Technical Service Bulletin

SUBJECT:			No:	TSB-19-33-001
	OL UPDATE FOR DUST COVER REF	-	DATE:	January 2019
			MODEL	See below
SERV	ICE MANUAL REV	/ISIUN	TIODEL.	
SERV	[] GENERAL MANAGER	(ISIUN [X] PARTS MANAGER		[X] TECHNICIAN

This TSB updates the Front Suspension section of the affected Service Manuals to update the special service tool used in replacement of the Lower Arm Ball Joint Dust Cover.

SPECIAL TOOLS

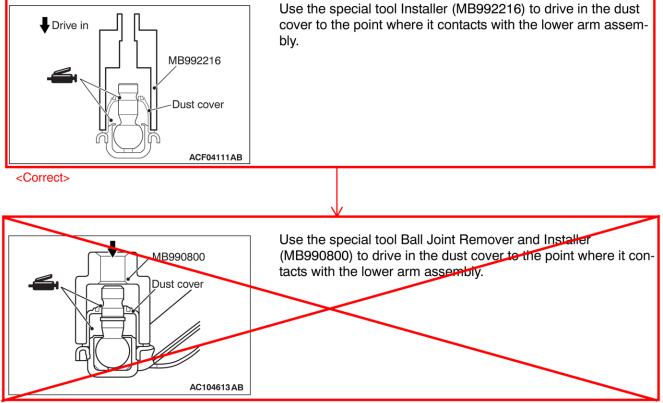
Please make the indicated changes below to the 2012 - 2017 i-MiEV Service Manual, Group 33-Front Suspension -> Special Tools.

<Incorrect>

Tool	Tool number and name	Supersession	Application
МБ990800	MB990800 Ball joint dust cover installer	MB990800-01or General service tool	Lower arm ball joint dust cover installation

<correct></correct>	SPECIAL TOOLS			
ΤοοΙ		Tool number and name	Supersession	Application
		MB992216 Installer	-	Lower arm ball joint dust cover installation
